USGS Washington Water Science Center

May 6, 2010

Subject: USGS responses to issues raised by the Technical Memorandum, "Review and reevaluation of Skagit River 1921 flood peak discharge."

Figure 1 -- High-water marks and peak water-surface profiles in the slope-area reach downstream of USGS streamgauge Skagit River near Concrete, WA Station Number 12194000 for the Dec. 1921 and Nov. 2006 floods.

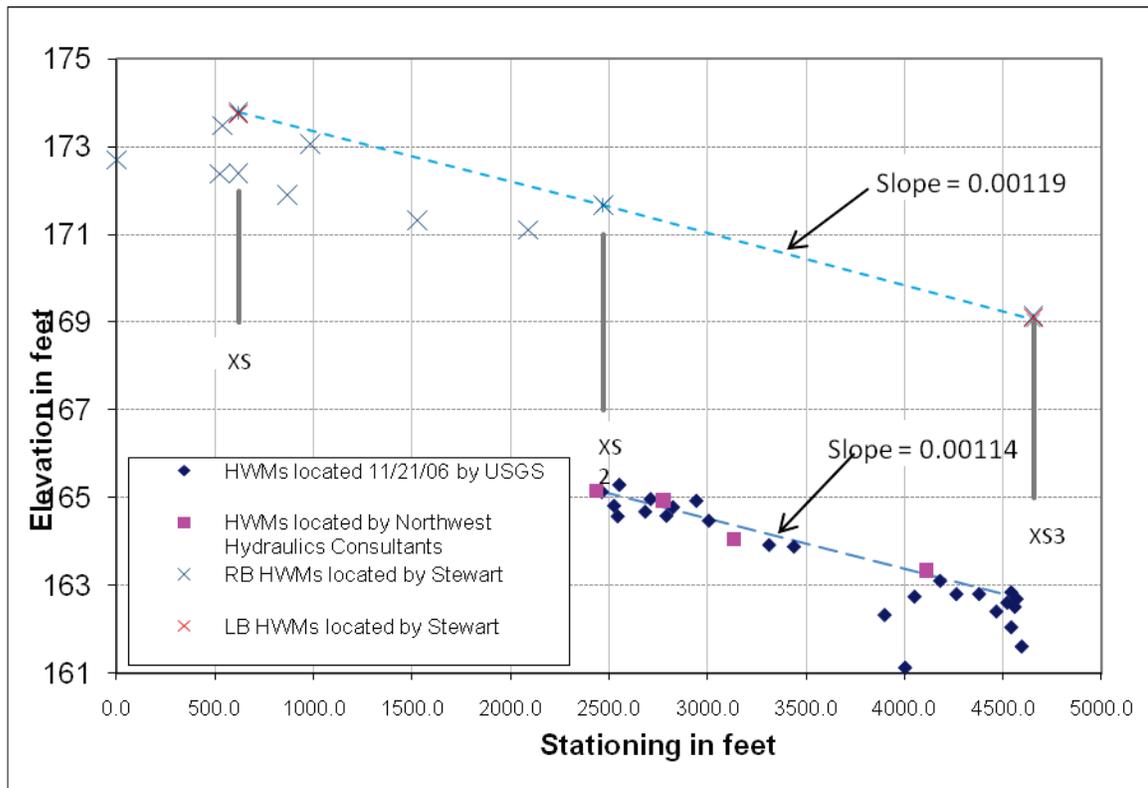
4. Unsupported hydraulic grade line slope used for upper slope-section reach.

Table 5 of the technical memorandum does not list all of the HWM data available for computing the flood flow estimates. A complete listing is provided below in table 1 and shows 13 HWMs available to Stewart including those surveyed by Wright and/or Thirint in 1923.

Stewart was careful in selecting highwater marks on which to base his water-profile. It is very rare for all high-water mark elevations that are identified in a field survey to be used or considered in determination of a water-profile slope. Some marks are clearer or more vivid and can be more precisely surveyed, because the seedlines, mudlines, or debris that defines them is narrower, more tightly banded, or more continuous than other marks. Even among those marks that are well defined, however, most serve as only low-elevation bounds on the peak high-water elevation simply because they did not occur at the peak flow but AFTER it has occurred. They are more numerous because they occur over a longer period of time, during the flood recession and in generally calmer, relatively low-water flows. Because they do not represent peak flow conditions, the USGS generally disregards the lower highwater marks in favor of the higher marks, particularly when multiple highwater marks provide confirmation of those higher elevations.

This is precisely what Stewart did. He emphasized the highest marks, attributing them to the water levels occurring at peak flow and the lower marks to water levels that occurred after the peak. On p. 25 of Stewart's 1923 report, "Floods in Skagit River Basin, Washington" he writes, "When looking for the 1921 crest, there was danger of obtaining a lower point than the flood crest." As such, the five marks that figure most prominently in the development of his surface-water profile were the most reliable estimates of the water profile during the peak flow. Significantly, two sets of marks (those of cross-sections 1 and 3) are confirmed by independent marks found on the opposite bank. Stewart did not blindly extend the profile from cross-section 2 and 3, he had highwater marks at both locations, and in addition to those he had marks along the reach from cross-section 1 and 2. The result was a single, consistent slope of 0.00119 feet/foot.

This slope has also been confirmed by other flood data. In November 2006, soon after a peak of 145,000 ft³/s, the USGS surveyed HWMs between locations approximating cross-sections 2 and 3 and defined a peak water slope of 0.00114 (fig. 1, Mastin 2007). This slope matches to within 3 significant figures the surface-water slope computed by Stewart.
